City of Redmond

Memo

Re: Tree Exception Request for Removal of Landmark Tree and 0% Tree Retention
Penny Lane II

- 14-unit townhome project in Downtown Redmond
- Site Plan Entitlement and Subdivision (LAND-2019-00399/00400)
- Location: Parcel nos. 7792900125; 7792900130; 7792900140 – Downtown – 170th Ave NE

Appendix B

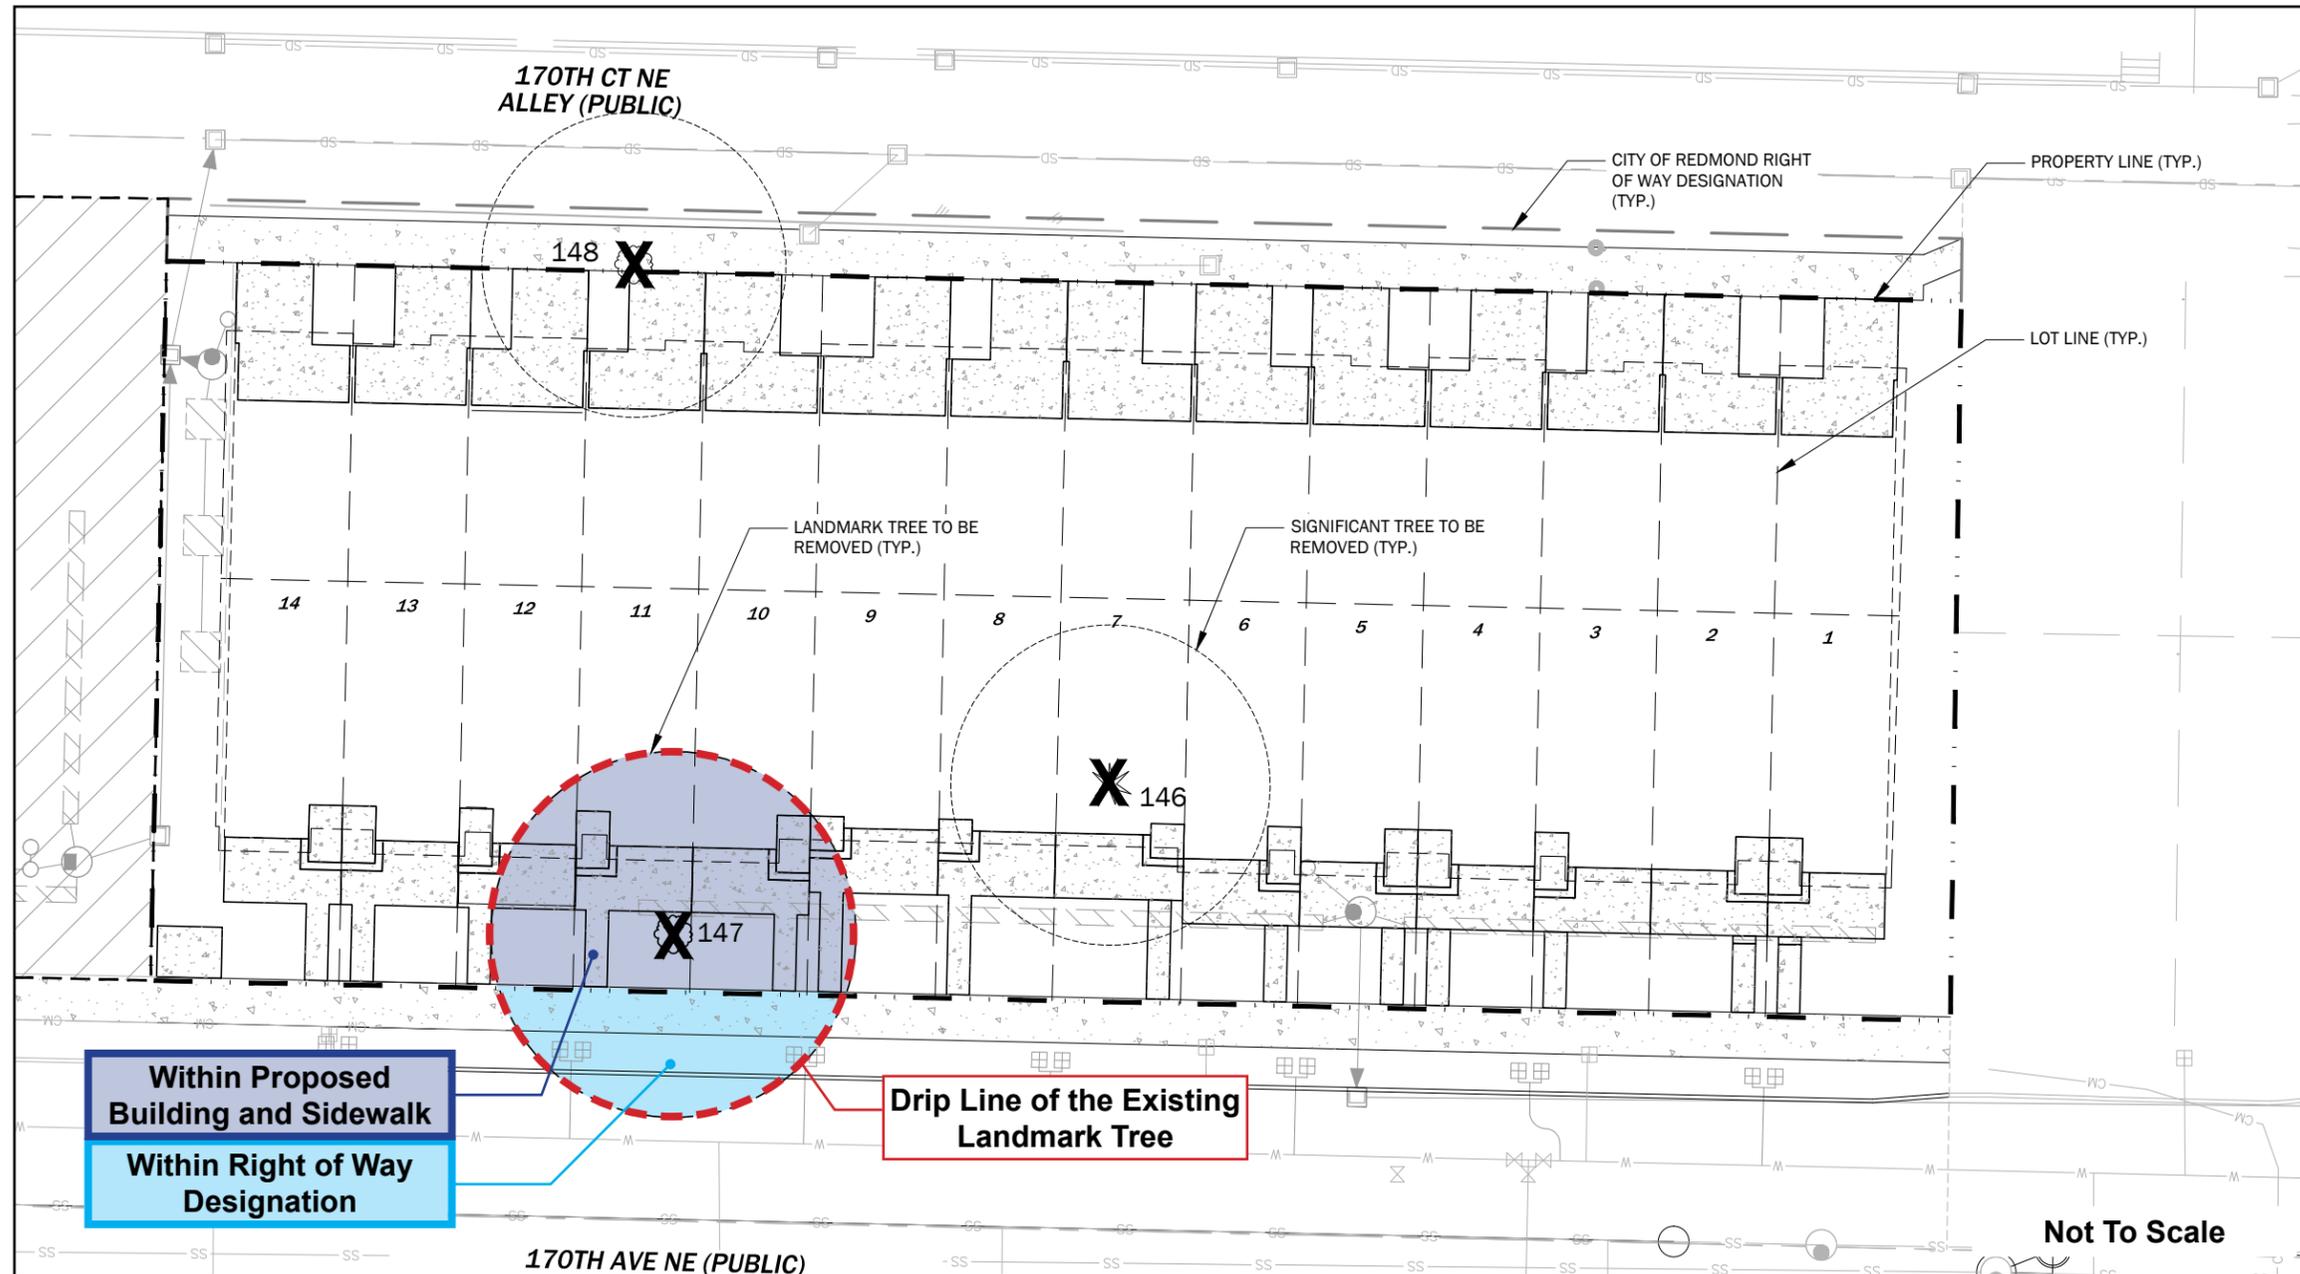
The 2 major factors that have stopped us from retaining the existing landmark tree are pedestrian circulation improvement (per RCZ 21.10.150) and allowed development density (per RZC Table 21.10.130A). As illustrated in Appendix B at the end of this document, it is unlikely for the landmark tree to survive in proposed development. It is also very possible to create hazardous situation that will jeopardize public safety and welfare.

As shown in the graphic on the left, the majority of drip line falls in proposed sidewalk and buildings. Given existing condition of the tree, as assess by Creative Landscape Solution (See the table at the bottom of this page), the tree is not in healthy condition currently. Considering the health and growing condition this tree is in, it is very likely it will become public health hazard if retained. Thus the removal becomes necessary.

Appendix C

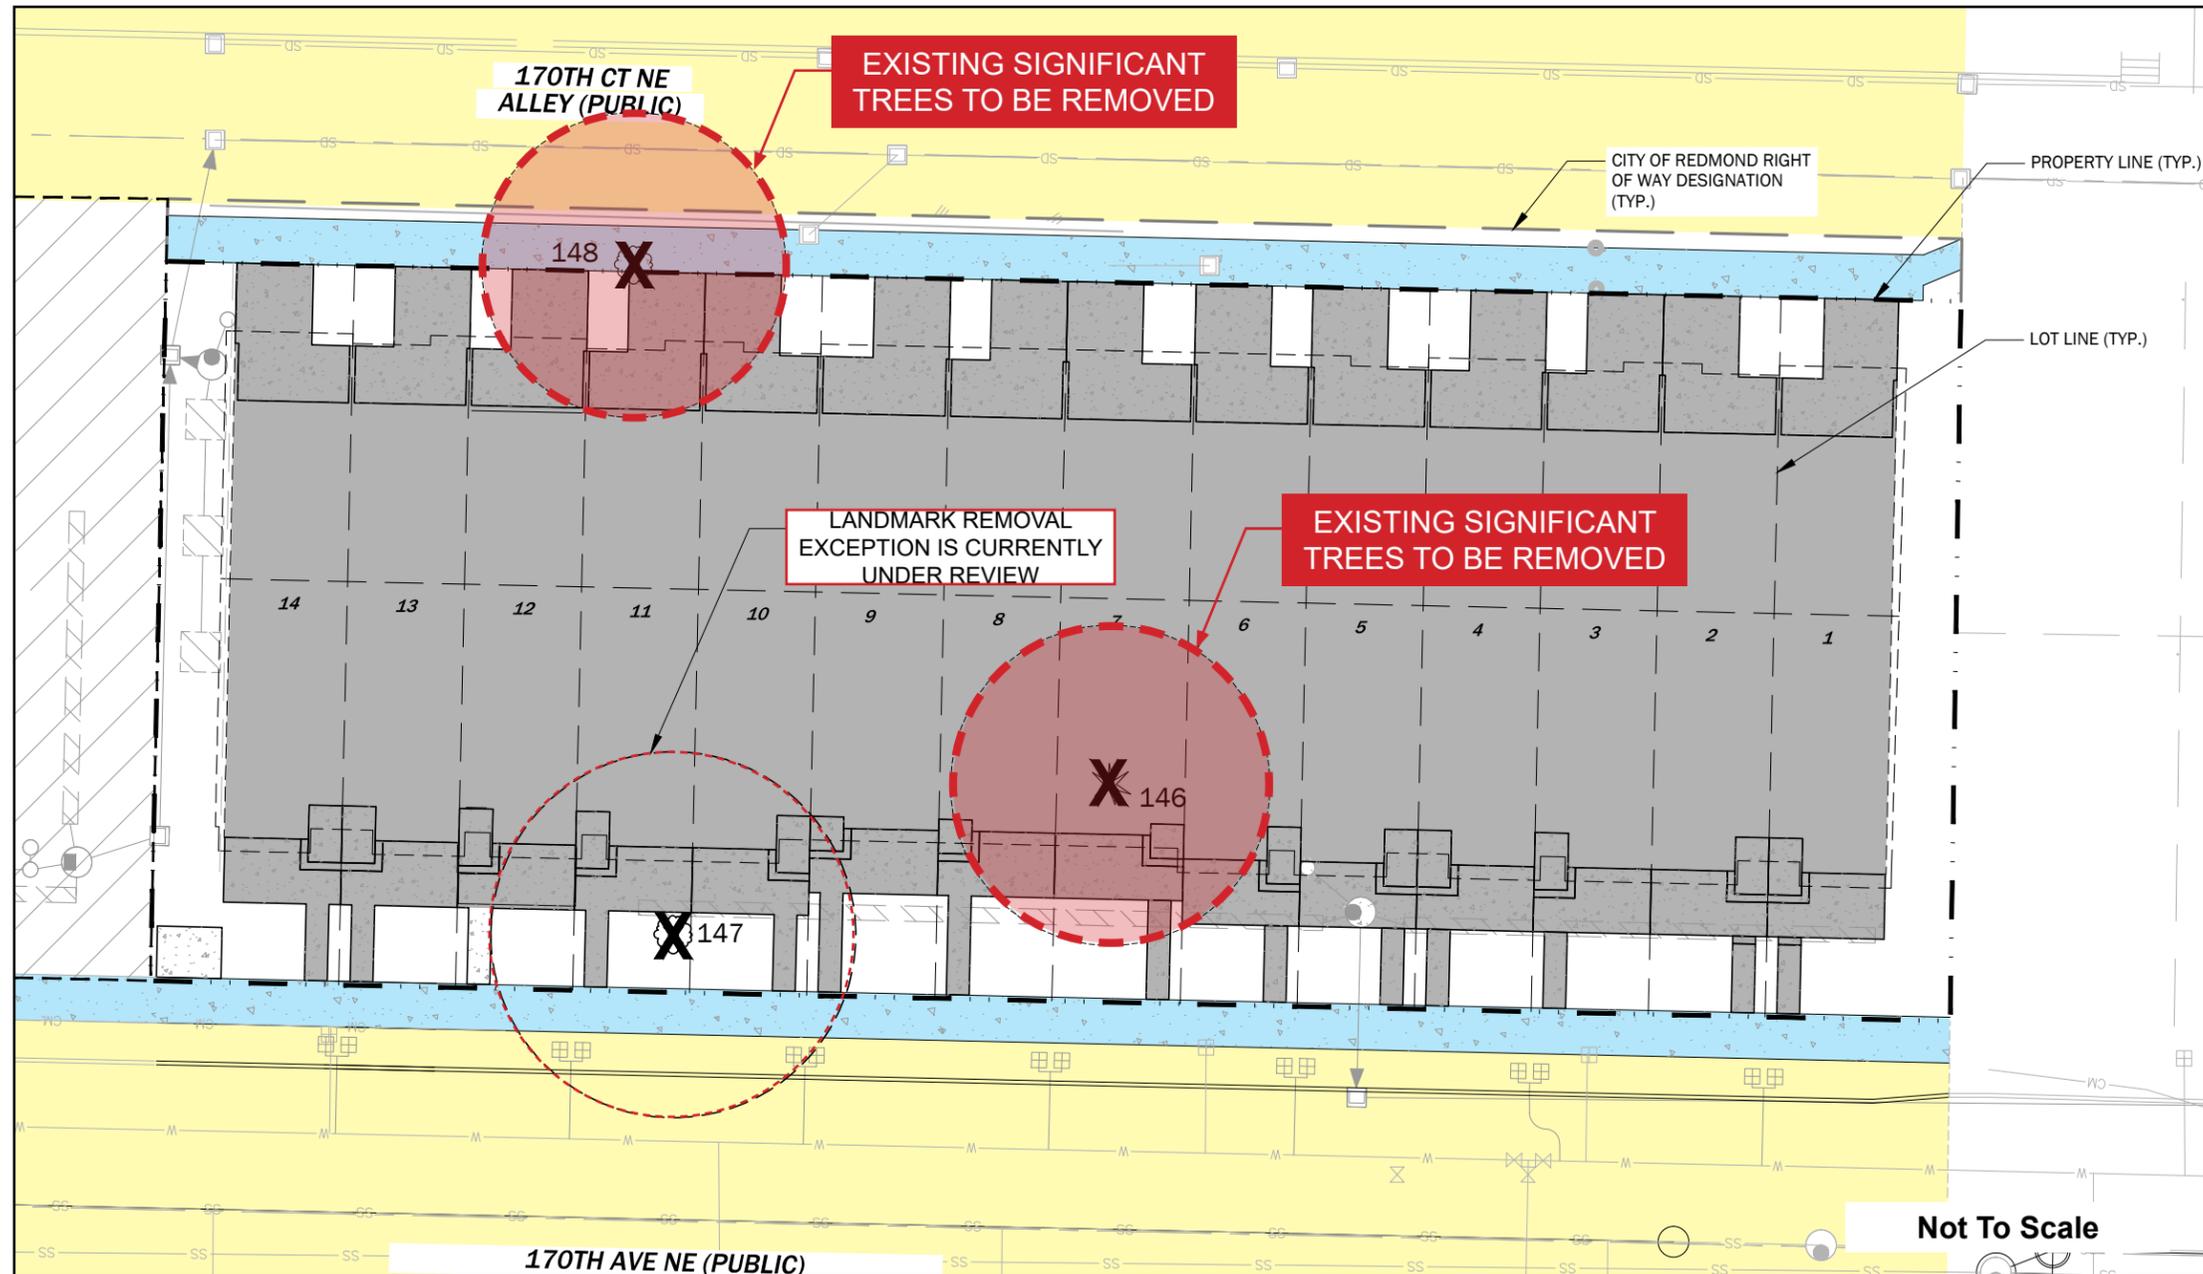
As shown in the graphic above, drip line of significant trees fall in proposed sidewalk and buildings, as well as existing public roads. Given existing condition of the tree, as assess by Creative Landscape Solution (See the table on the right), the trees are not in good health. Considering the health and growing condition these 2 trees are in, it is very likely it will become public health hazard if retained. Thus the removal becomes necessary.

PRELIMINARY TREE PRESERVATION PLAN

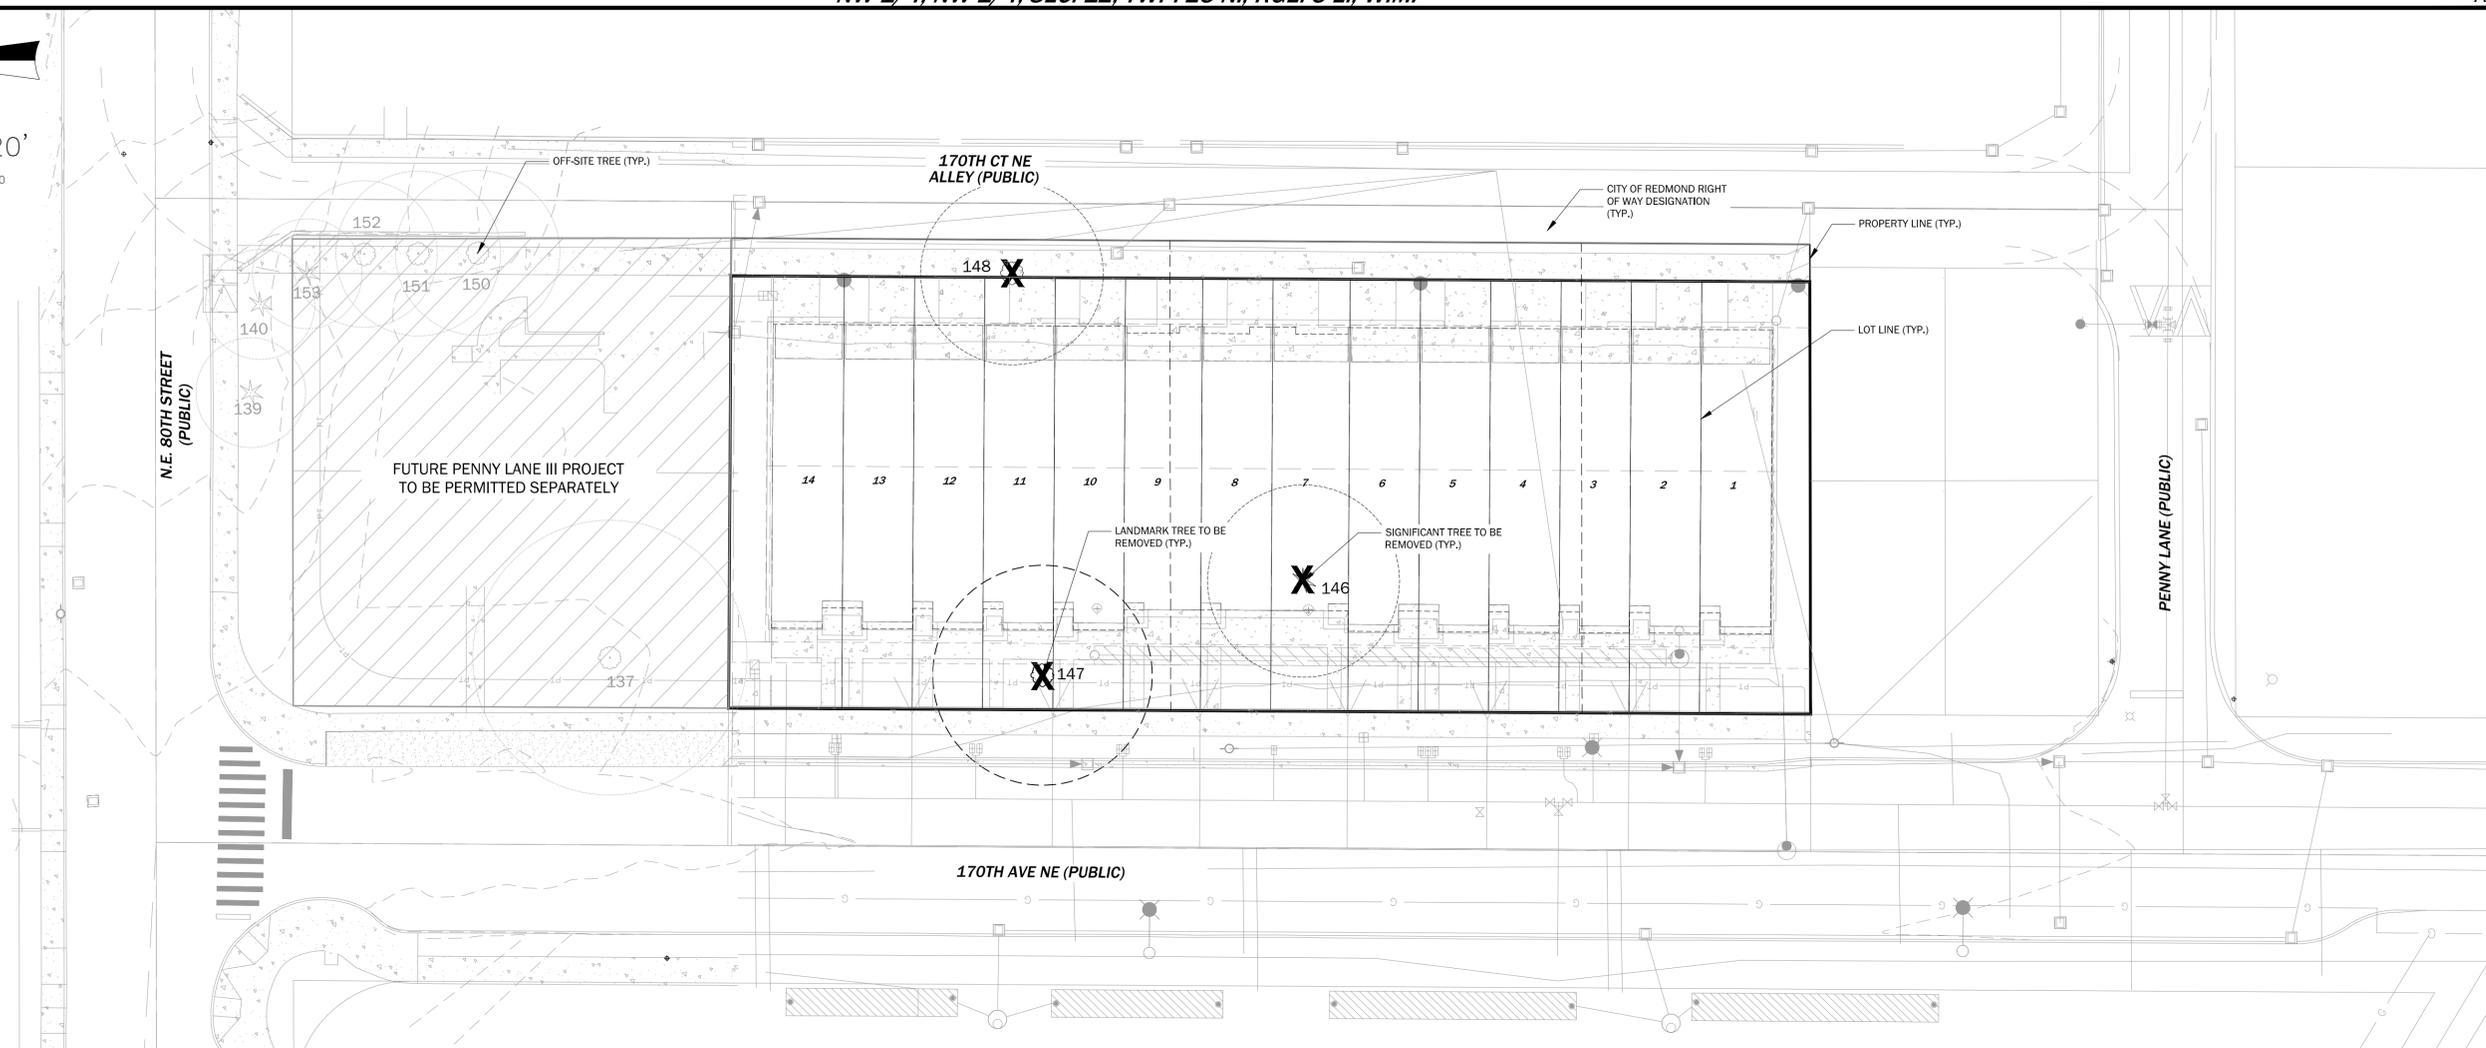
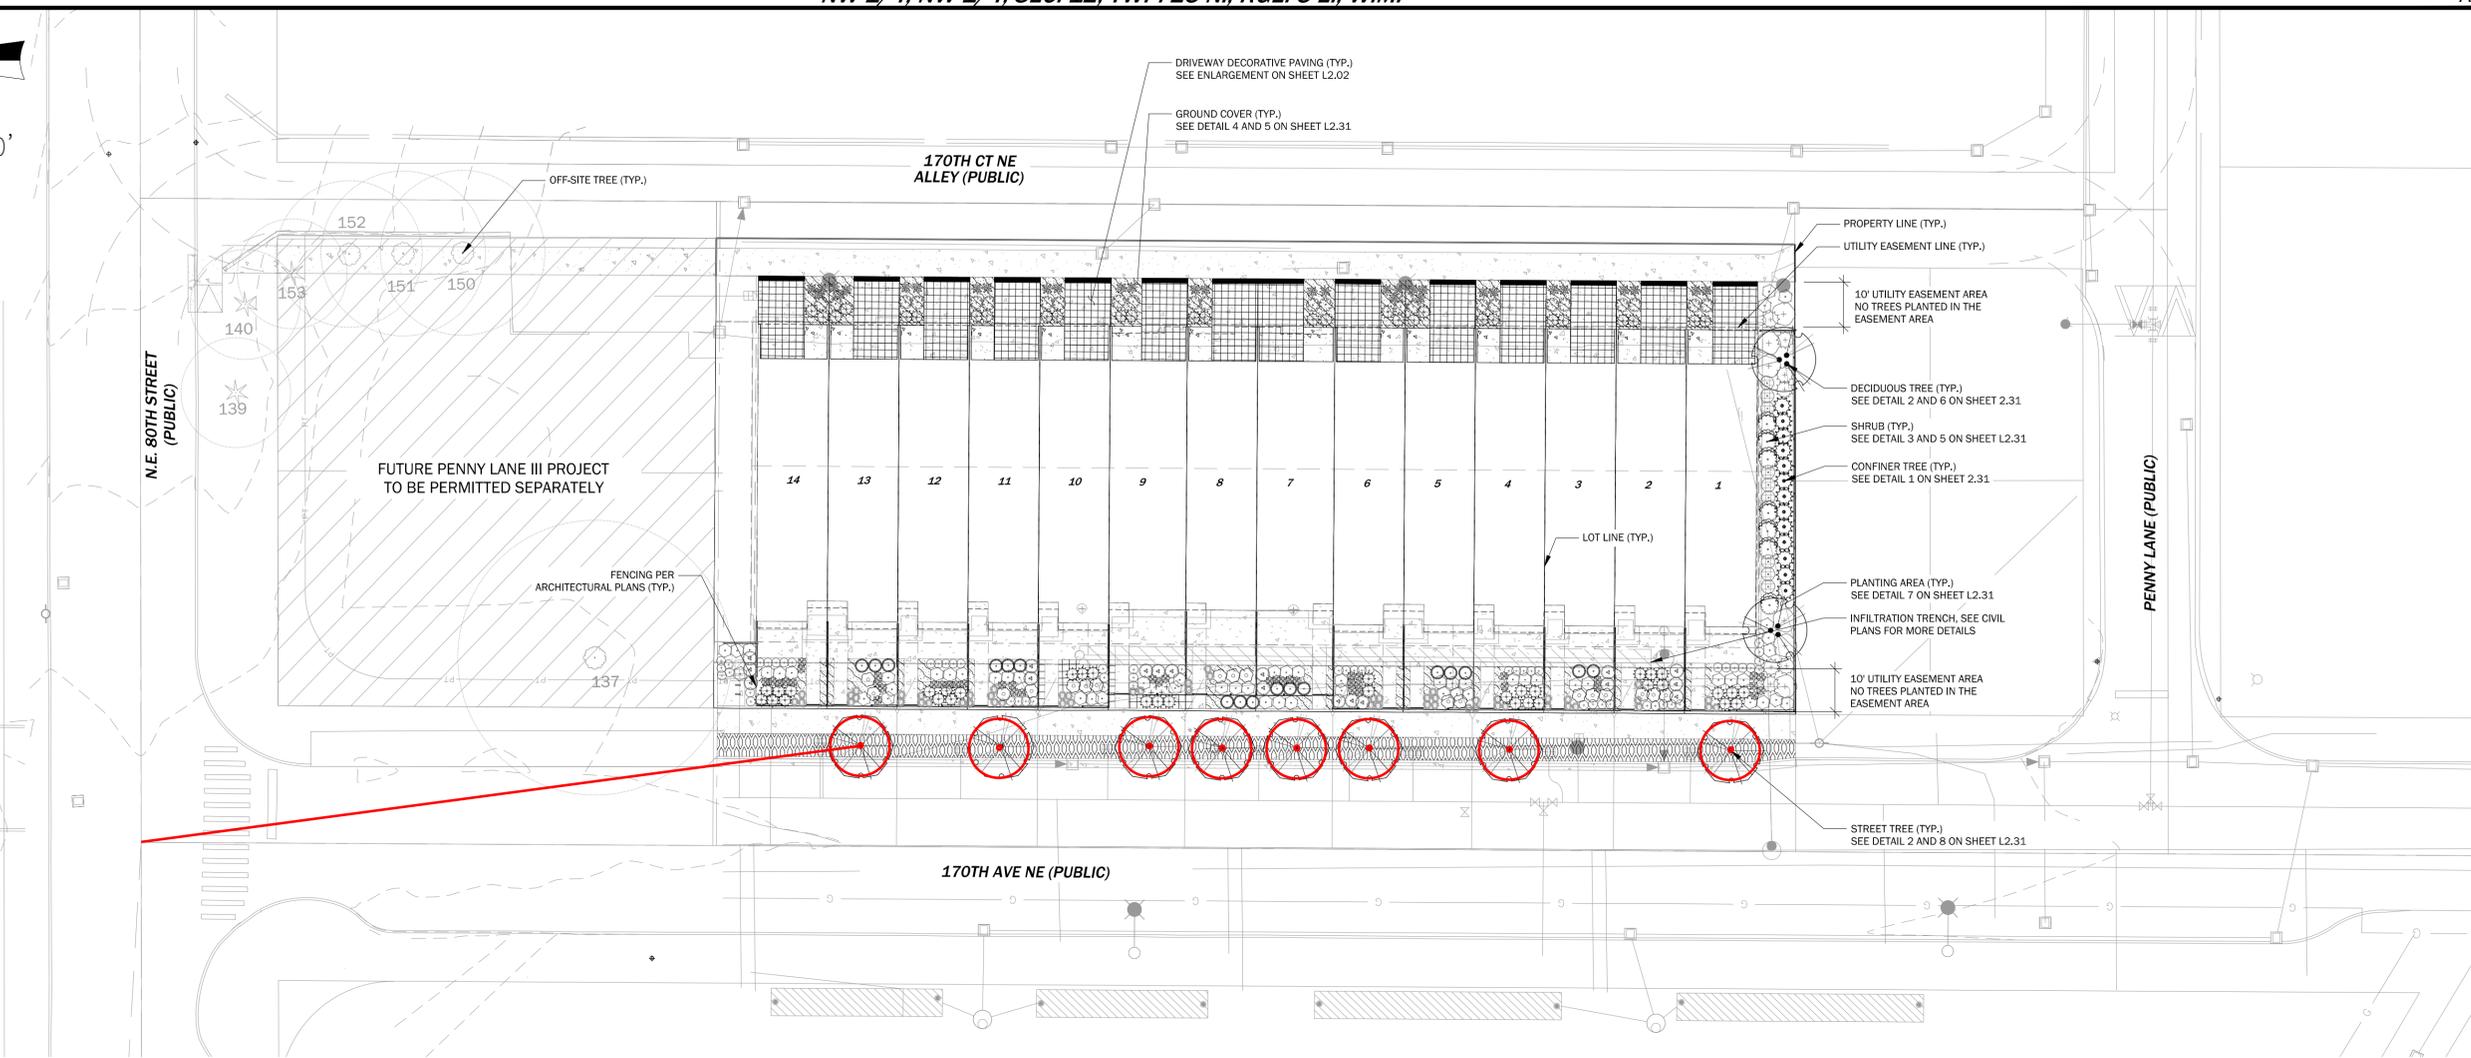
- Approve the removal of one (1) landmark tree as the tree is in the developable portion of the subject site (see attached site plan).
- Approve the removal of two (2) significant trees for a 0% significant tree retention as shown in the attached tree preservation plan
- Applicant has also provided the attached landscaping plan which provides 6 additional replacement trees above minimum 9 required replacement trees for a total of 15 replacement trees on site. **This landscaping will be required to be installed as part of Preliminary Plat/Site Plan Entitlement approval.**
